STATE OF MAINE  
DEPARTMENT OF TRANSPORTATION  
16 STATE HOUSE STATION  
AUGUSTA, MAINE  
04333-0016

May 20, 2008  
Subject: **Auburn**  
Project No. STP-1159(800)X  
Pin No. 011598.00  
**Amendment No.1**

## BRICK SIDEWALK

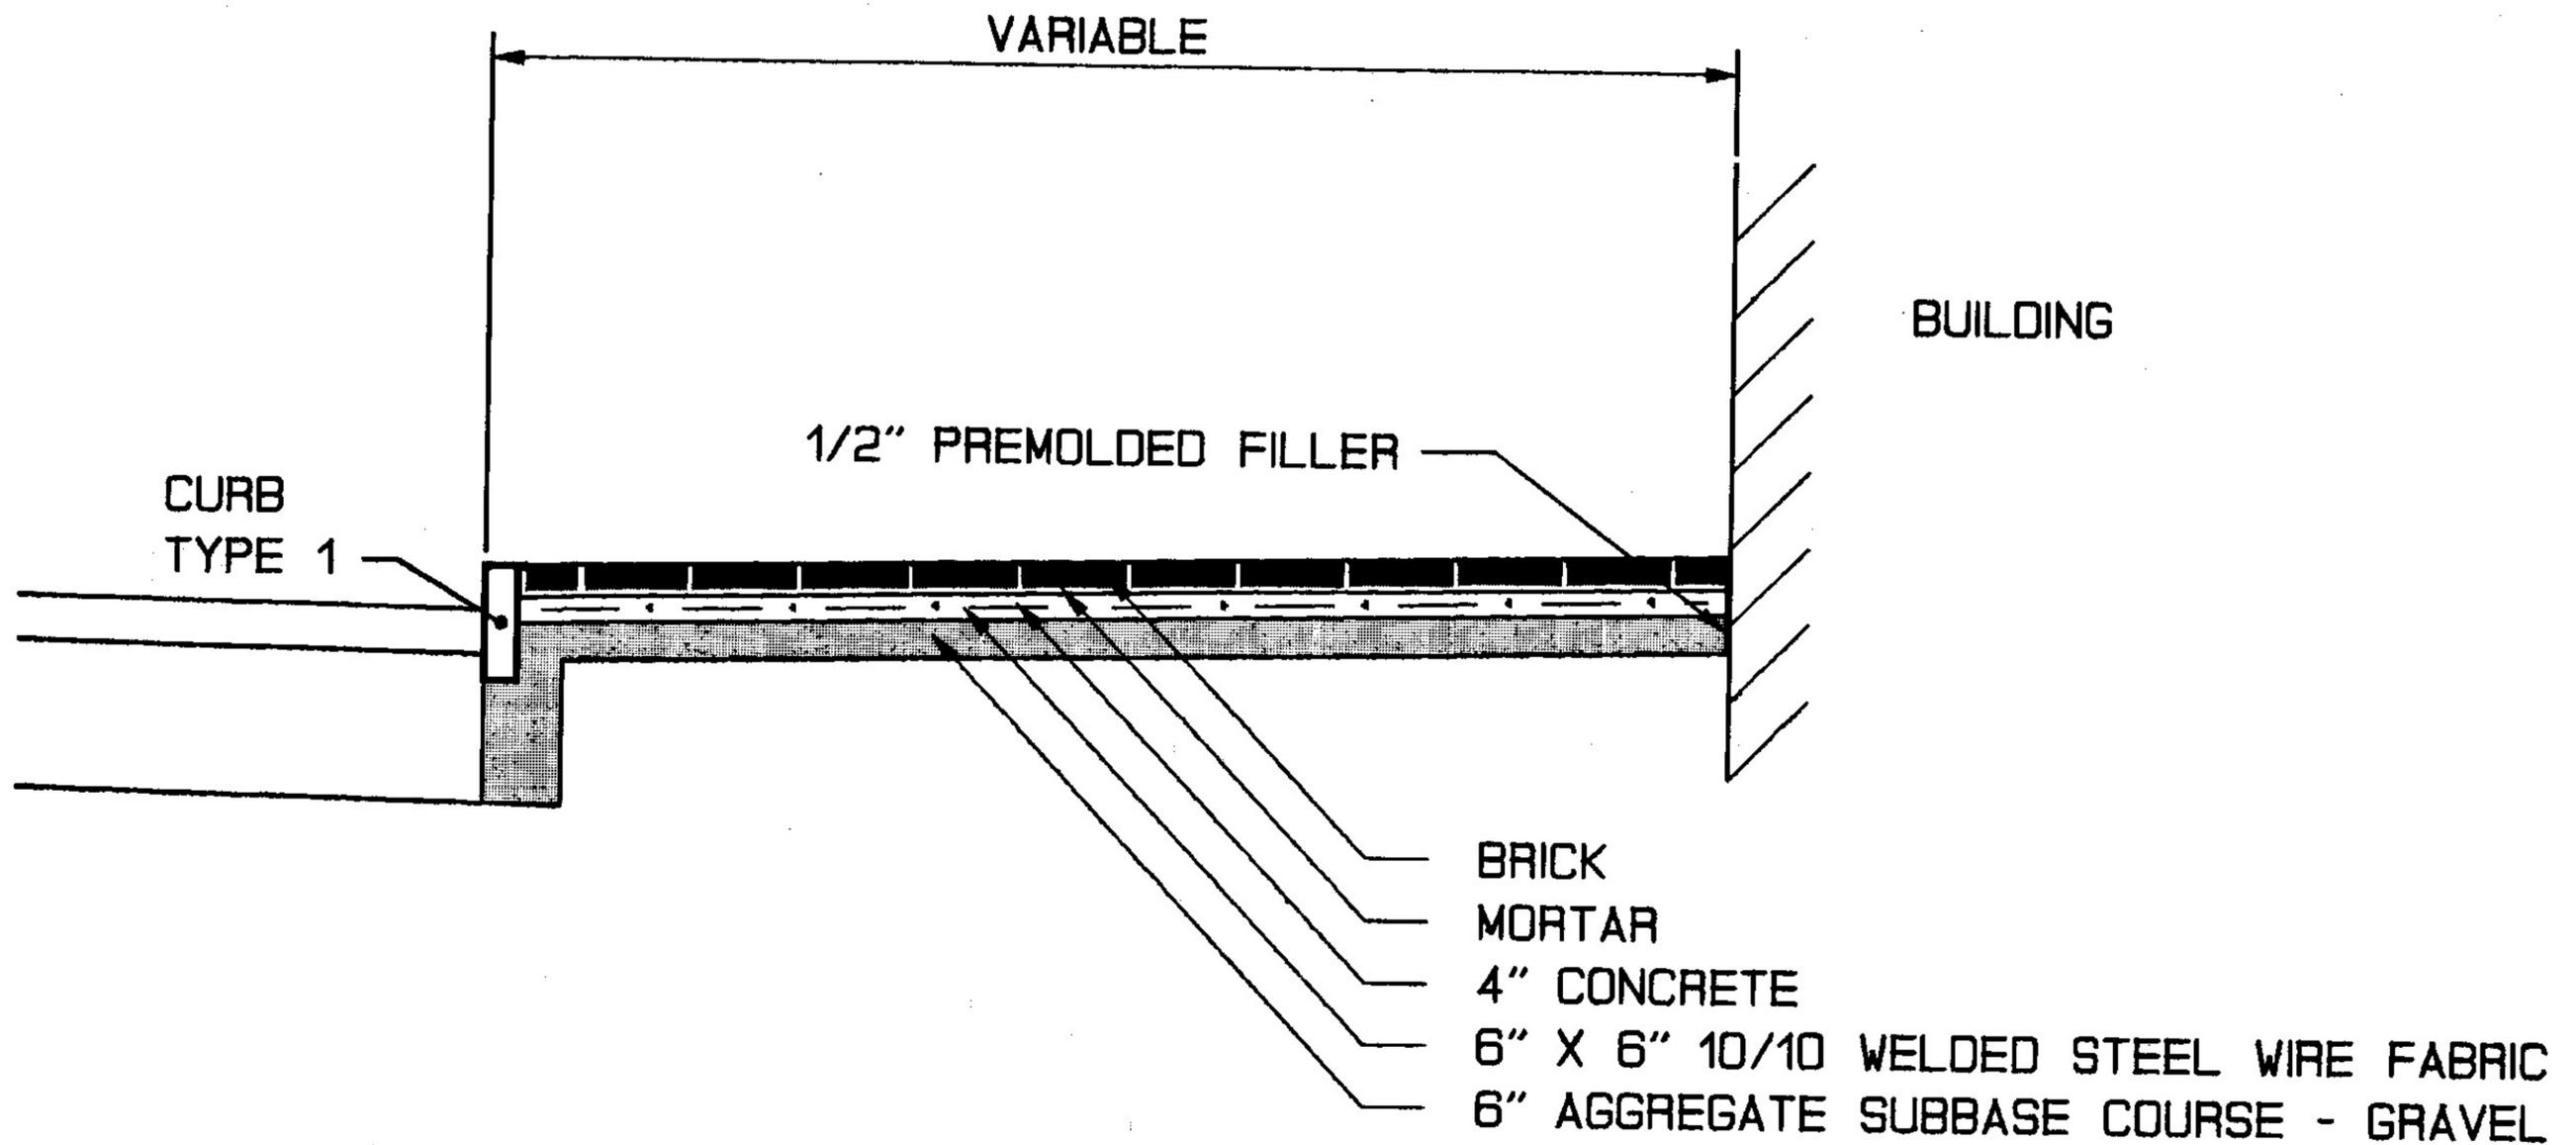
In the Plans; on Sheet Number 3 of 38, **DELETE** the "BRICK SIDEWALK" detail (upper right hand side) and it's associated note. **REPLACE** with the attached new BRICK SIDEWALK detail and note.

NOTE: EXPANSION JOINTS FOR BRICK AND CONCRETE SIDEWALKS SHALL BE LOCATED ONE OVER THE OTHER WITH MAXIMUM SPACING OF 30'-0" CENTER TO CENTER. ALL BRICKS ARE TO BE CUT WITH A POWER SAW OR PROPER CUT-OFF WHEEL.
